Steven M. Clouse WRC Electrical System Improvements Phase 2A

Job No.: 21-6507

ADDENDUM 2

August 10, 2021

SHEET NO.
40E04
321 OF 328

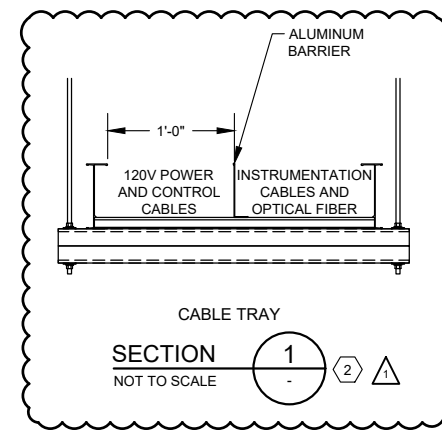
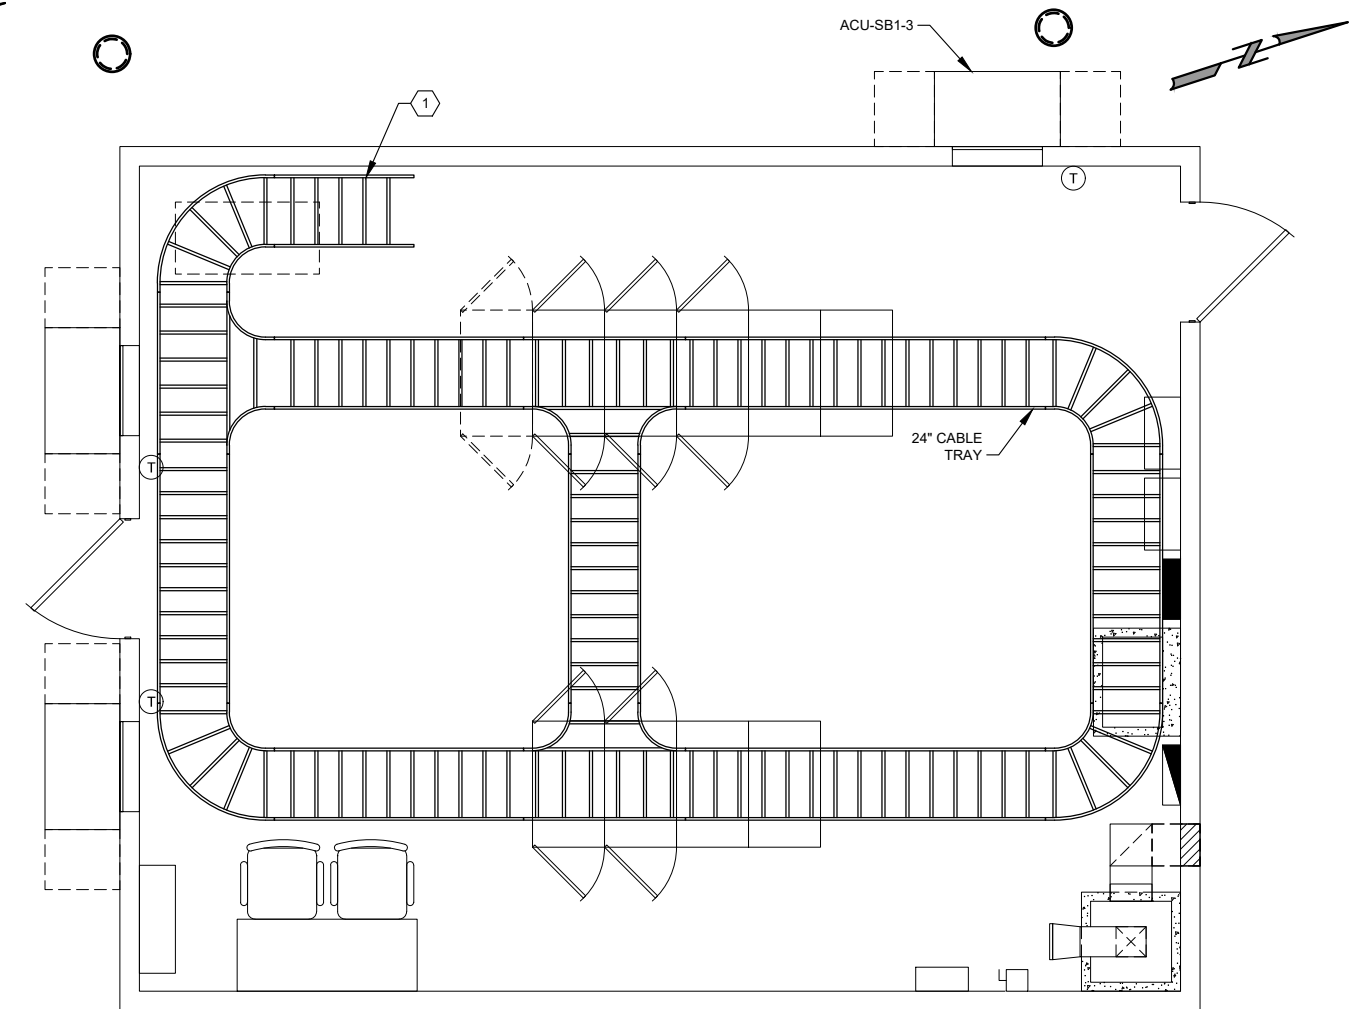
6. Sheet 40E04 cable tray plan does not identify # of levels nor does it show divider barrier requirements. Considering the tray will have 480V Power, 120V Power, Control as well as Instrument cables, please clarify whether there are to be multiple levels or divider barriers

Response: Single layer of cable tray. 480 V power to run in conduits (not tray). 120V power and control can run in same tray section; instrumentation, communications, and fiber to run in other section with single barrier in tray. Refer to Changes to the Plans item "h. 40E04."
